TYLIN INTERNATIONAL
The stamped documents are hereby:
____ Approved
____ Approved as noted
_X_ Revise and resubmit
See transmittal for additional information as applicable.
This review is for general conformance with design concept only. Any deviation from the plans or specifications not clearly noted by the Contractor has not been reviewed. Review by the Engineer shall not relieve the Contractor of the contractual responsibility for any errors or deviation from the contract requirements.
Josh Olund 08/01/2016
Reviewer Date

VT 100 Road Culvert
Duxbury, Vermont

Culvert Layout - Plan and Elevation

1 S1.0 ARCH CULVERT JOINT CONNECTION DETAIL
1" = 1'-0"

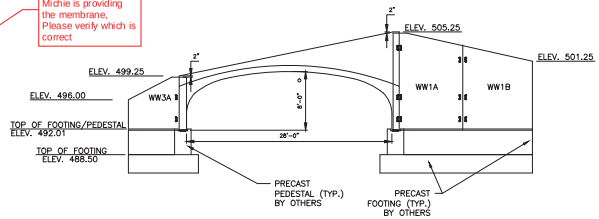
Arch Culvert Note 10 below suggests Michie is providing the membrane. Please verify which is correct

1 S2.0 ELEVATION VIEW
⅜" = 1'-0"

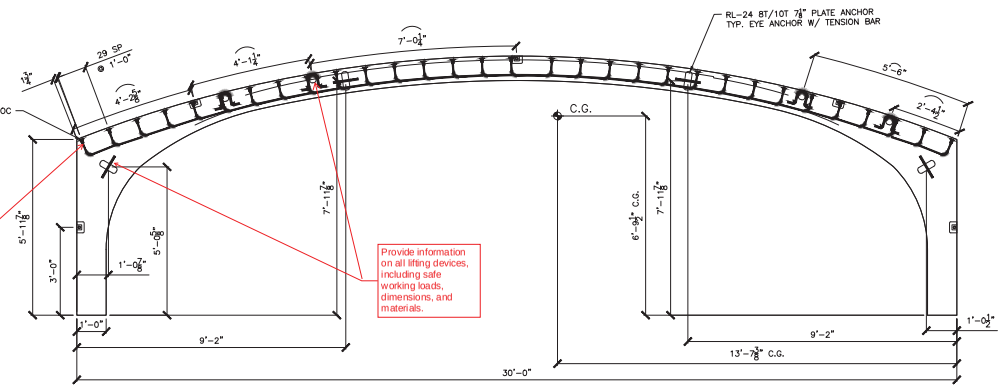
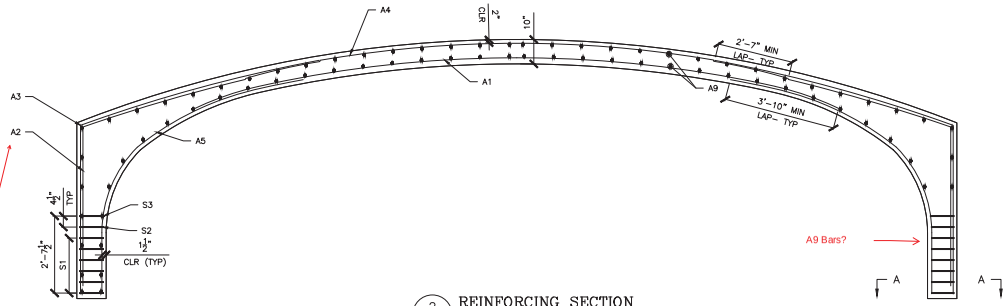
Provide bend details. 3 additional couplers need to be provided to VTrans. If the distance between the bell and the beginning of the bend is less than 7 inches, then the 3 couplers provided to VTrans should be straight (without the bend).

Provide information on all lifting devices, including safe working loads, dimensions, and materials.

Bar "A2" is shown adjacent to "A3" in the view above, but bundled with "A5" in section view below. Please coordinate the two views and clarify where "A2" is to be placed

verify placement order of A9 bars and A2 bars. View above shows A2 bars inside of the A9 bars; this view does not reflect that.

The number of bars does not match Section AA nor the "Size/Spacing" column. Please coordinate.

currently 76 drawn in the view above, without the addition of any in the right leg

1 S3.0 AC-1 PLAN VIEW
⅜" = 1'-0"

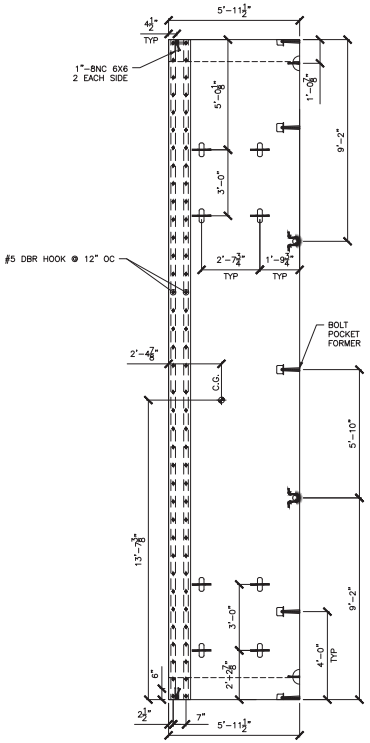
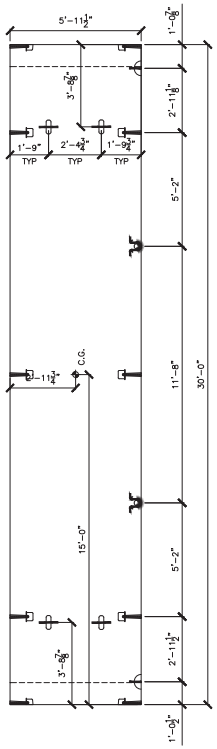
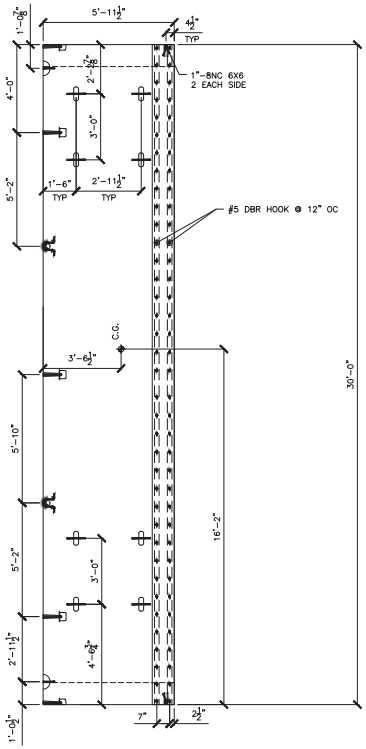
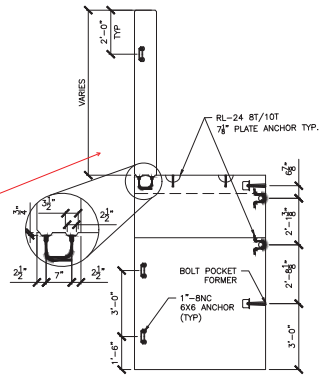
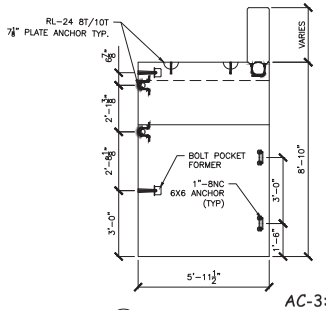
The headwalls are to be plumb after installation on site, and the arch will be tipped 1%. Need to adjust geometry of arch and headwall to achieve the required geometry and fit-up with the wingwalls.
